Westinghouse Electric Corporation
Atomic Fuel Department
Cheswick, Pennsylvania

Building 5-B
Atomic Fuel Department
Cheswick, Pennsylvania

NUCLEAR SAFETY CONTROL MANUAL

June 1, 1961

Fig. 2
 Powder Storage Vault
 Scale: 1" = 2'-0"
 6-15-61 LPH

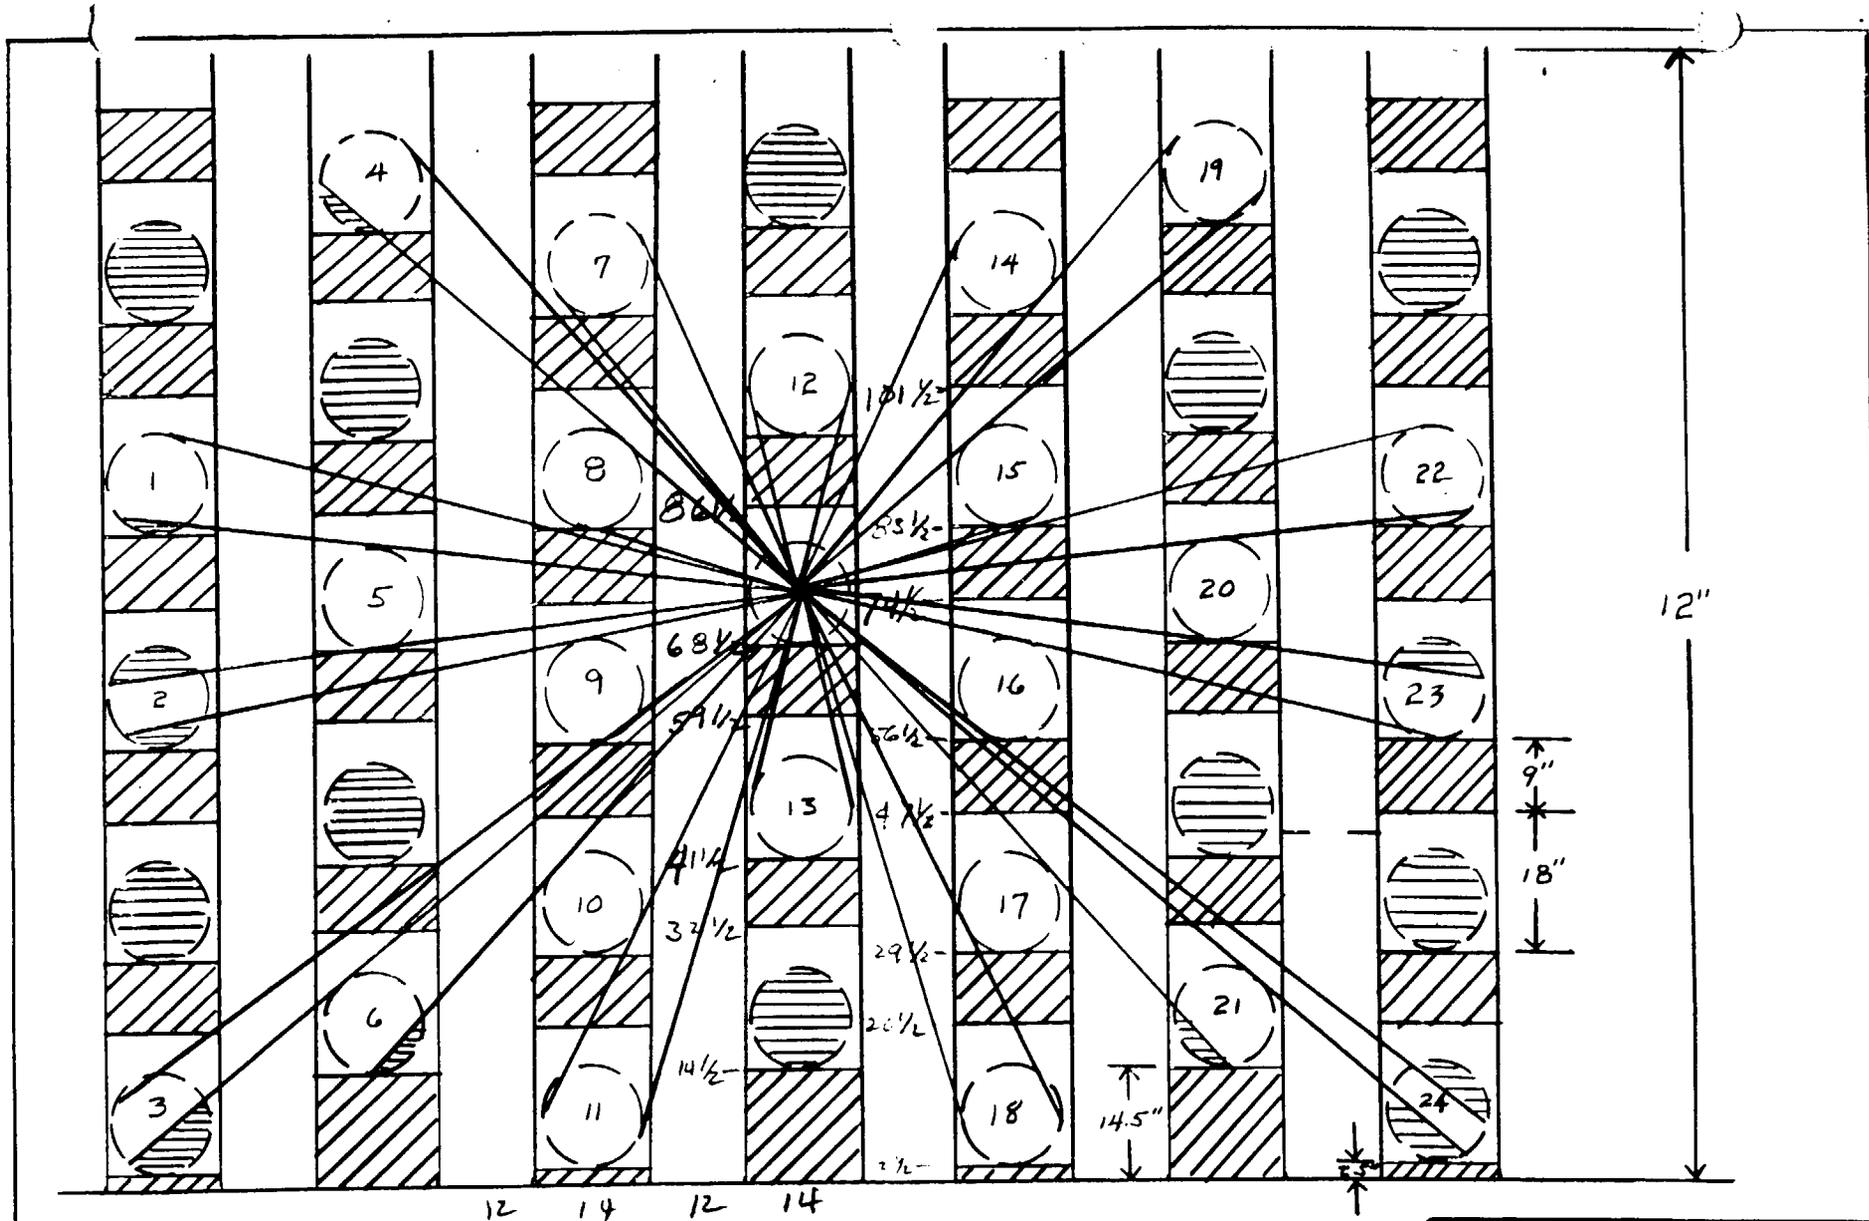
$\Omega_{\text{Total}} = 1.85301$ checked and OK based on
 $\Omega_f = 0.1475$ more detailed written

Why → (circled 15)

$\Omega = 1.05$
 0.723
 2.58 OK
 Based on max control

Fig. 3

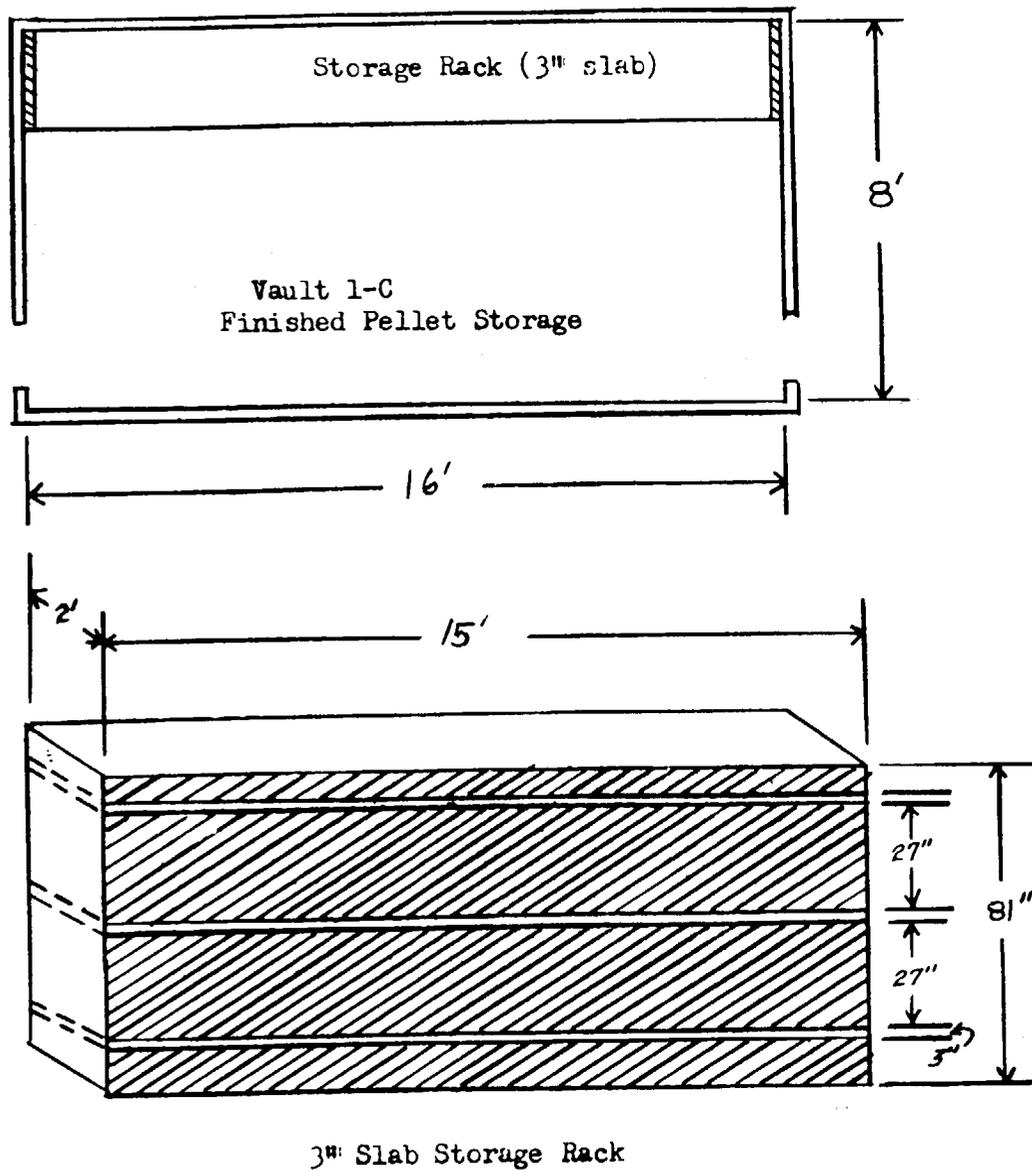
*must assume k_{eff} = 0.8 for geometry -
 see Fig 26 TID 7016
 angle is ~ 0.8*

Fig. 5

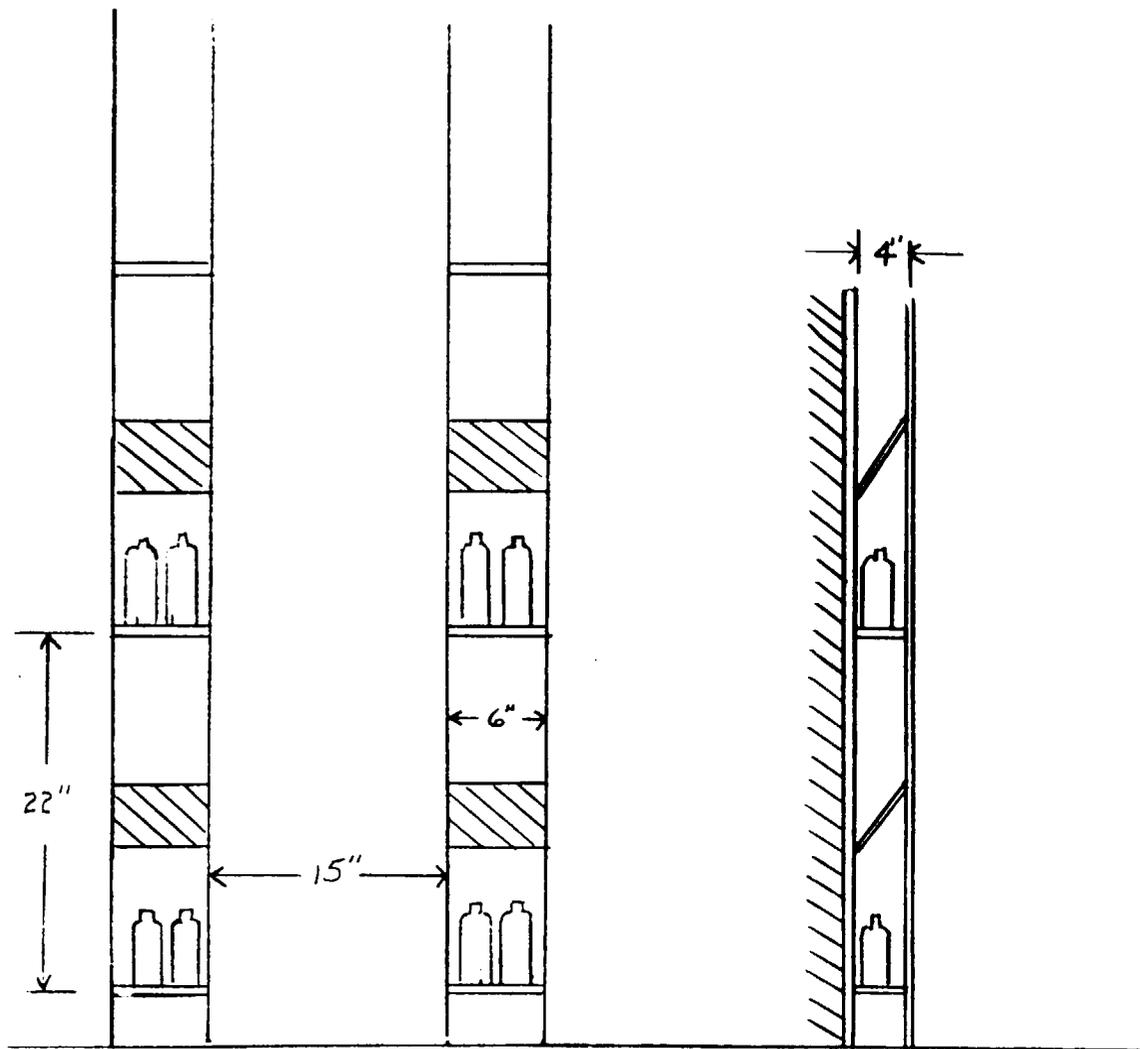
L = 12 ?

mix - mixing mass control
with geometry control - geometry
control would take precedence
therefore Ω_T should be less
than 0.8

note - Ω should be less than 0.8
